City of Bellevue

June 21, 2021

RE: Pinnacle South Master Development Plan
10116 NE 8th St
Application #21-104954-LP

The purpose of this letter is to give you revision comments by City staff regarding the proposed master development plan for a mixed-use building project located at 10116 NE 8th Street. When you submit the requested information and changes, please provide a written response to each comment. Additional information may be requested as a result of our review of your re-submittal to the following issues. If you would like to meet to discuss these comments prior to submitting revisions, you may call individual reviewers or me at your earliest convenience.

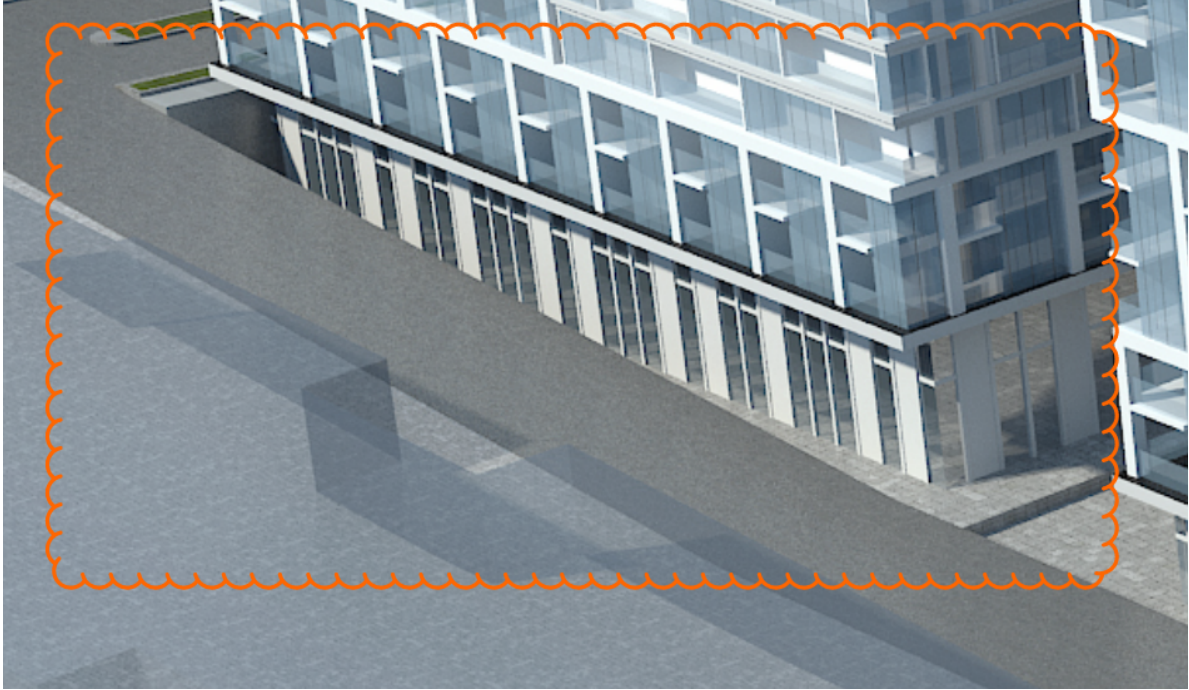
9. Identify if any proposed balconies encroaching onto the sidewalk and utility easement. Vertical clearance of 60-feet above sidewalk grade is required due to the small wireless facilities and potential tree conflicts. Show the outline of the Balconies on the Civil plans and combined illumination and street trees plans for review of adequate horizontal and vertical clearances.

3. Building Elevations

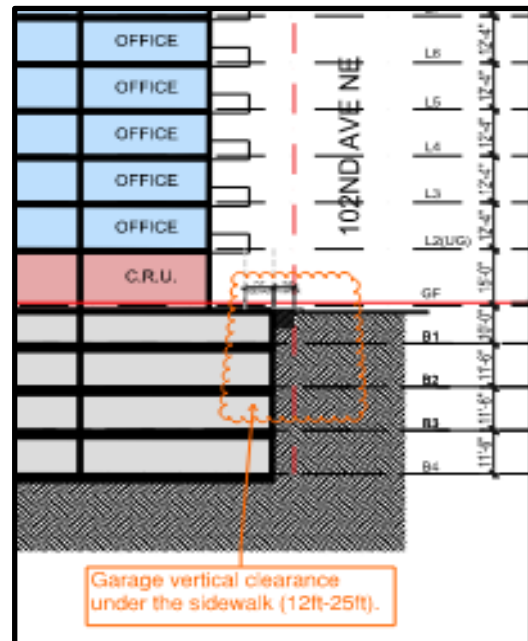
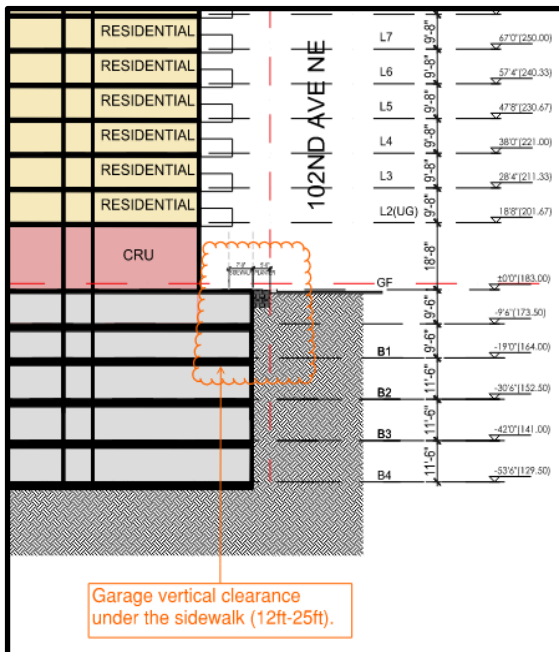
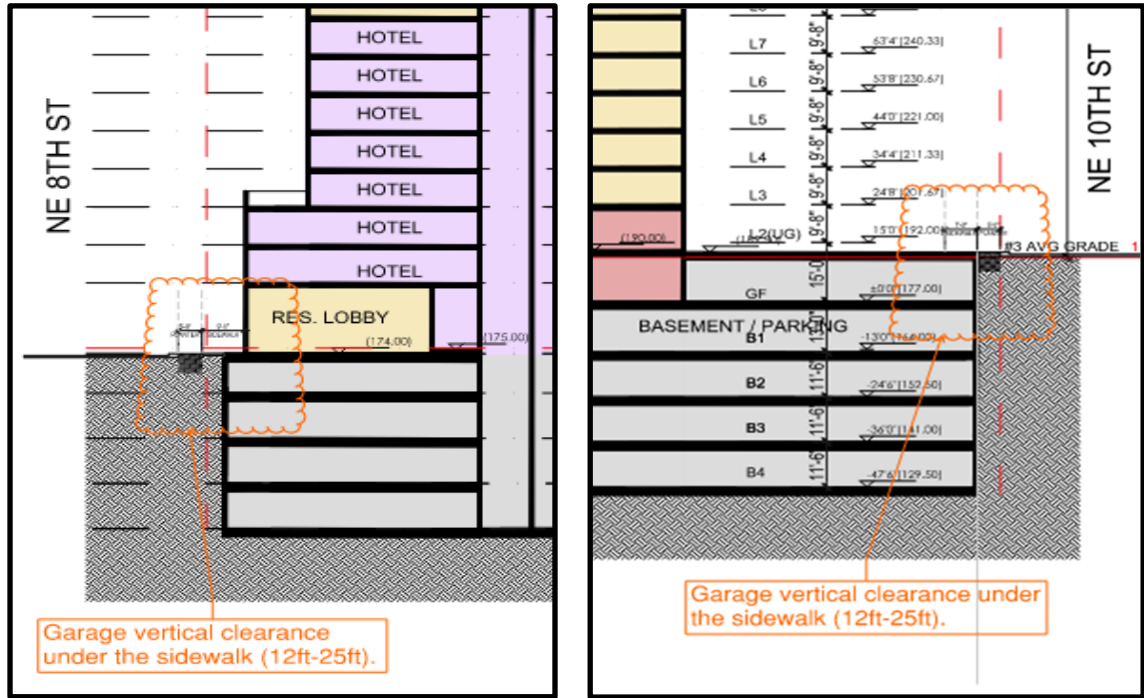
- a. Vertical clearance below sidewalk and utility easement shall be maintained to the back of the required sidewalk width. Refer to Sidewalk and Utility easement requirements.

4. Design Vehicle and Turning Templates:

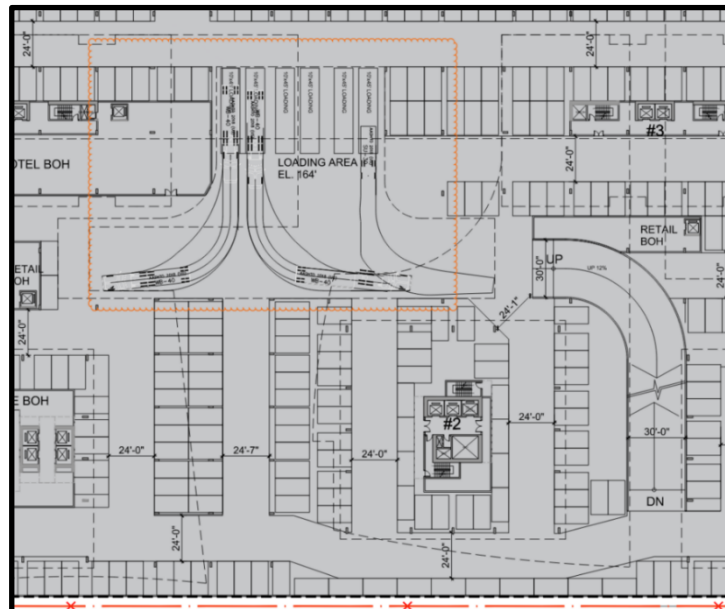
- a. P1 Plan A1.05: Architectural plan shows WB-40 lading space in the garage. Provide AutoTurn turning movements simulation showing access from the driveway and through the garage.
- b. Coordinate with Traffic and Civil plans – see plan sheet C6.0 Turning Plan and comments below
